# Access Compliance Report

## Public Rights-of-Way

Intersection ID: 11625	Main Street: E_11TH_ST	Cross Street: N_COLLEGE_ST	Location: W
ADA ID: 3B4919098420	Ramp Type: PerpDiag	Initial Pass/Fail: Fail	Overall Compliance: No
Severity Score: 12.5			
Codes/Mitigation Info/Possible Solution		Field Measurements/Component Compliance

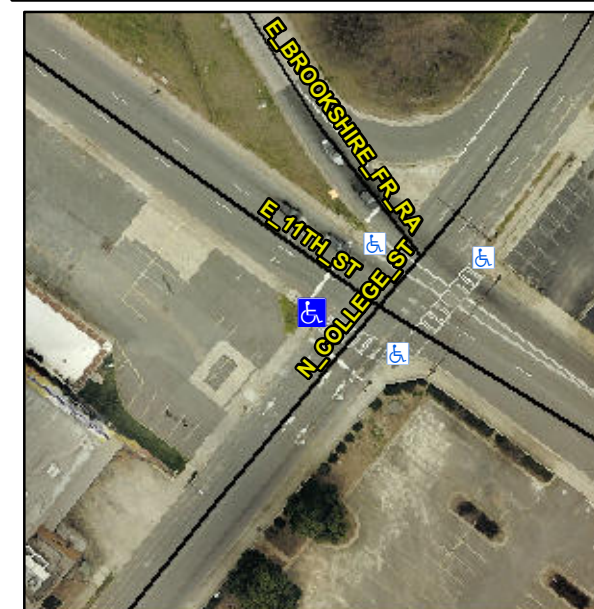
**Not Found, R304.2.2**

Compliance	Description	Data	Compliance	Description	Data
N/A	Ramp Length (in)	42.0	No	Ramp Slope (%)	10.8
Yes	Ramp Width (in)	48.0	Yes	Ramp XSlope (%)	0.2
N/A	Flare Type LT	N/A	N/A	Flare Type RT	N/A
N/A	Flare Slope LT (%)	N/A	N/A	Flare Slope RT (%)	N/A
N/A	Flare Traversable LT?	N/A	N/A	Flare Traversable RT?	N/A
N/A	Landing Length (in)	N/A	N/A	DWS Provided?	N/A
N/A	Landing Width (in)	N/A	N/A	DWS Contrast?	N/A
N/A	Landing Slope (%)	N/A	N/A	DWS Length (in)	N/A
N/A	Landing X Slope (%)	N/A	N/A	DWS Full Width?	N/A
N/A	Landing Curb? (Y/N)	N/A	N/A	DWS Offset (in)	N/A
N/A	Shared Landing?	N/A			
N/A	Gutter Ponding?	Yes	N/A	Gutter Slope (%)	N/A
N/A	Gutter Lip Ht (in)	N/A	N/A	Gutter X Slope (%)	N/A
N/A	Painted X Walk1?	Yes	N/A	Painted X Walk2?	No
	X Walk 1 Direction	To SE		X Walk 2 Direction	To NE
N/A	X Walk 1 Width (in)	118.0	N/A	X Walk 2 Width (in)	N/A
	X Walk 1 Slope (%)	1.1		X Walk 2 Slope (%)	3.3
	X Walk 1 X Slope (%)	3.9		X Walk 2 X Slope (%)	1.6

**Remove & Replace Curb Ramp With Two New Directional Ramps or Equivalent.**
